Final Plat
SUBDIVISION REPORT

S/D No.: 86-96 Name: THE PARK 2ND ADDITION

# THE PARK 2ND ADDITION

Re: Final Plat S/D 86-96 - THE PARK 2ND ADDITION

FINAL PLAT

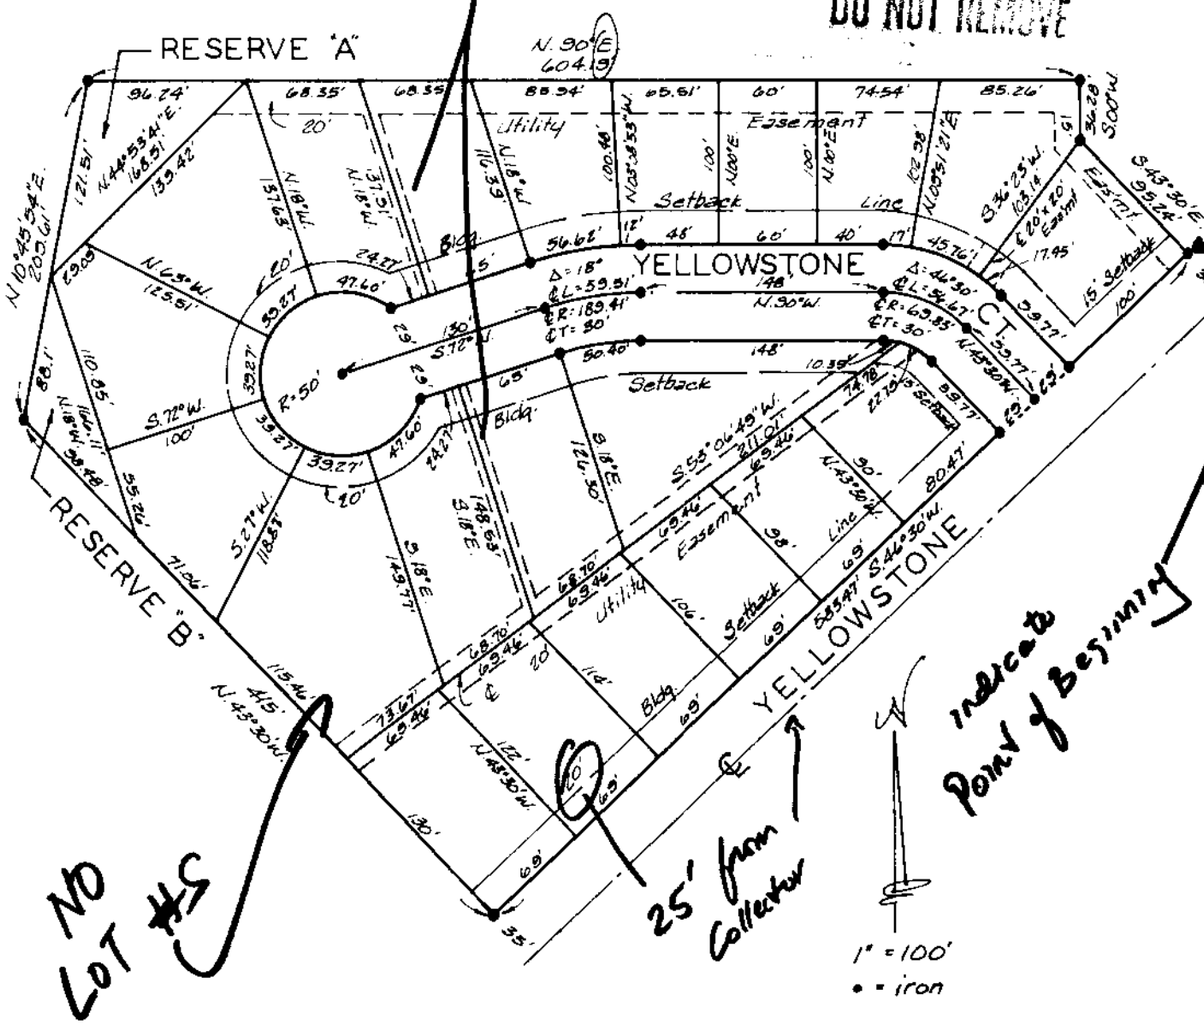
L. On the final plat tracing, the "Point of Beginning" shall be indicated on the face of the plat.

M. On the final plat tracing, the discrepancies between the face of the plat and the engineer's text shall be eliminated.

O. On the final plat tracing, the first line of the plattor's text shall be amended to reference the platting of the reserves.

P. On the final plat tracing, all utility easements shall be labeled and, where applicable, their centerlines shall be indicated.

Q. On the final plat tracing, a 25-foot front yard building setback shall be platted on the lots that are fronting on to the collector street (Yellowstone).

H. As this final plat fails to indicate lot numbers, the final plat tracing shall indicate lot numbers in the same order and arrangement that were shown on the preliminary plat.

I. The final plat tracing shall state in the plattor's text the purposes of the proposed reserves as well as who is to own and maintain the reserves.
